SUBJECT: ISSUANCE OF SSER 2 FOR GESSAR II

UNITED STATES
NUCLEAR REGULATORY COMMISSION
WASHINGTON, D. C. 20555

GESSAR II describes a standard BWR/6 nuclear island design. Consequently, GESSAR II does not describe an entire facility, but is limited in scope to those design and safety features associated with the nuclear island design. The design scope is defined in the SER and GESSAR II Section 1.2. GESSAR II also defines interface requirements that must be imposed on the reference plant (individual applicant referencing GESSAR II) so that the balance of plant (BOP) will provide compatible design features that will ensure the applicability, functional performance, and safe operation of the GESSAR II systems.

Figure 15.5 GESSAR II ultimate plant protection system

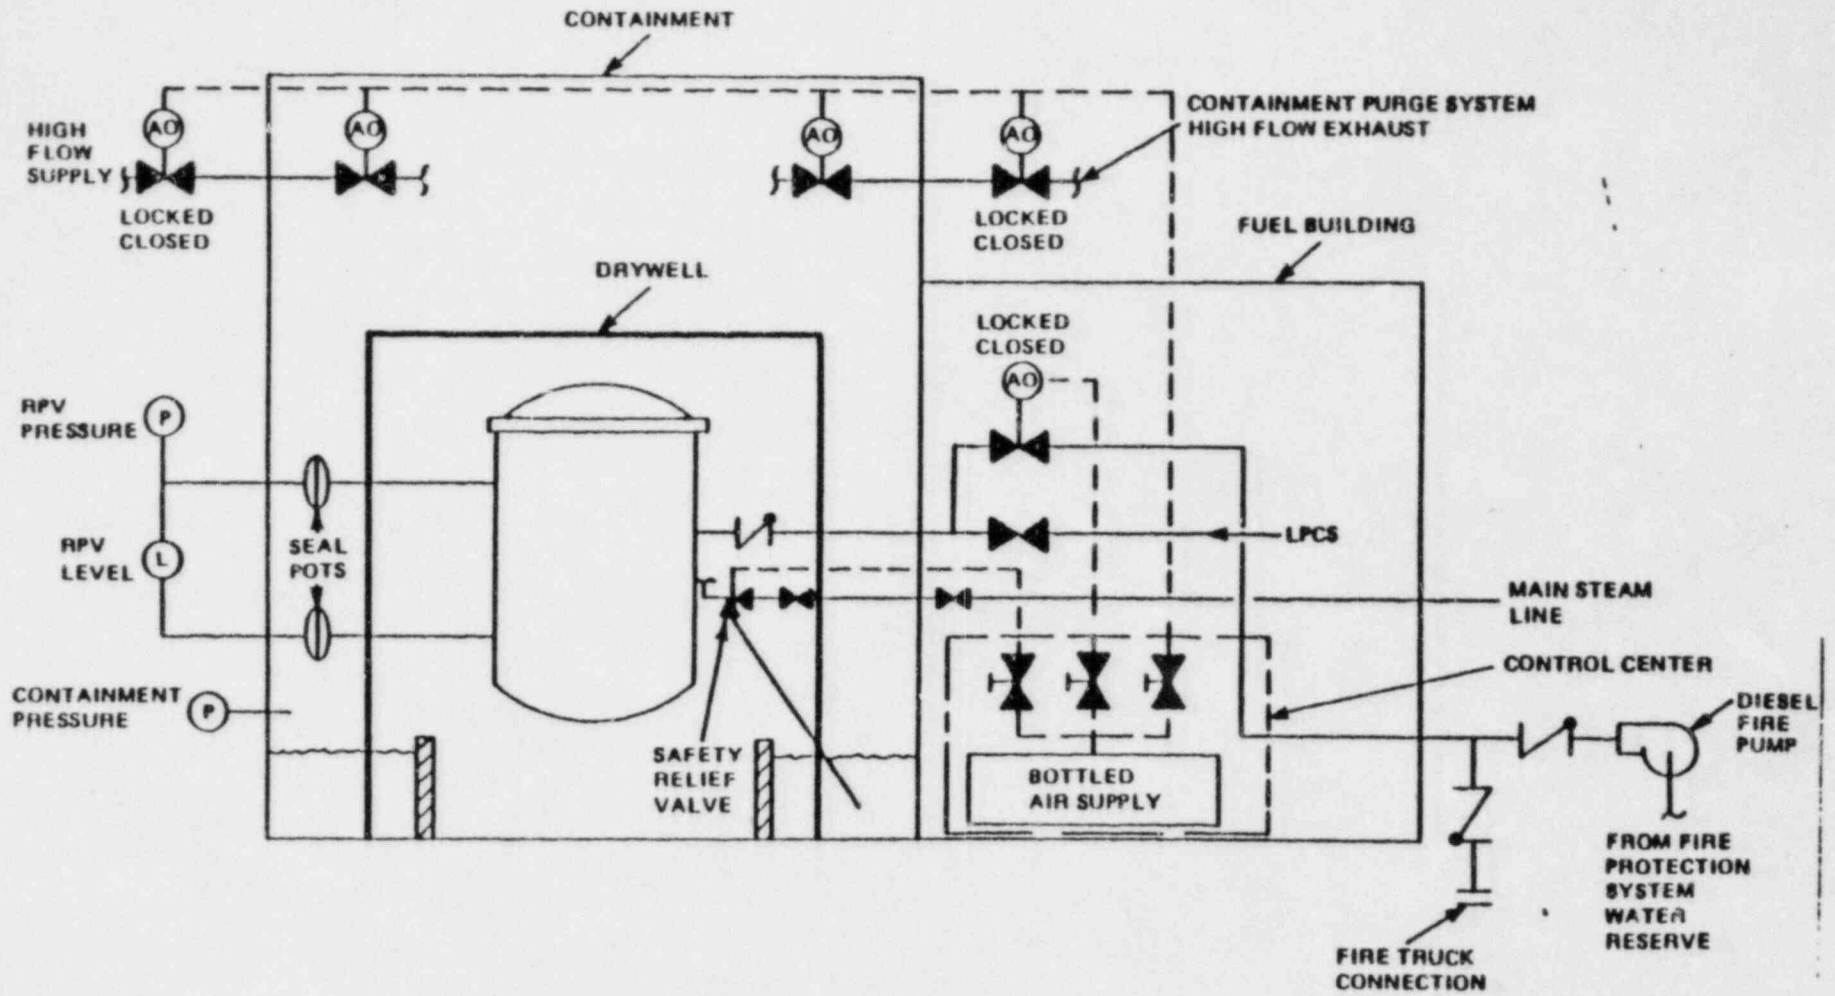
On the basis of a preliminary review of UPPS, the staff agrees that the UPPS appears to have merit in providing a backup low-pressure coolant makeup supply and in mitigating containment overpressurization. Figure 15.5 is a simplified schematic drawing of the UPPS. This system is designed to provide a connection allowing hookup of the fire protection system or a fire truck to the low-pressure core spray (LPCS) system injection line, thus supplying makeup to the
